RE: Data Responses, Set 2C
Cosumnes Power Plant (01-AFC-19)

COSUMNES POWER PLANT (01-AFC-19)

DATA RESPONSE, SET 1G

Figure 1: Graphical Depiction of the Clay Creek HEC-RAS Model

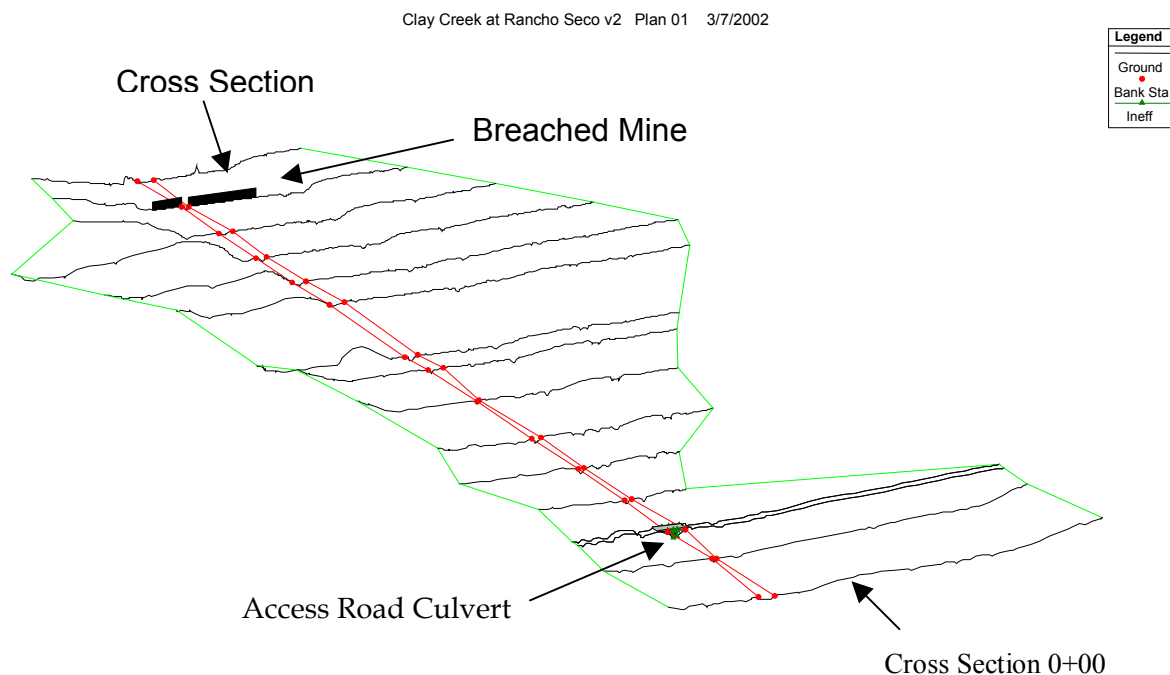
This analysis was performed to identify the potential for flood risk associated with the 100-year discharge at the proposed project site.

Report Organization

The geometry and roughness data and the boundary condition data were input to the HEC-RAS model to represent the conditions at the project location. Figure 1 is a graphical representation of the conditions at the project reach as modeled in HEC-RAS. The model was constructed to best represent the expected flow path of the 100-year

discharge. Given the nature of the site, it was assumed that the 100-year discharge would split into two channels upstream of the breached mine dam and then flow in both channels and across the floodplain between the two channels down to the access road culvert at the downstream end of the site. To capture this behavior, the breached mine dam was modeled as a blocked obstruction that forces water to flow around it when the flow capacity of the breach is exhausted. The culvert was modeled as a

Water surface elevations were calculated for the 100-year peak discharges of 1837 cfs and 920 cfs. Table 2 summarizes the 100-year peak discharge water surface elevations calculated by the HEC-RAS model.
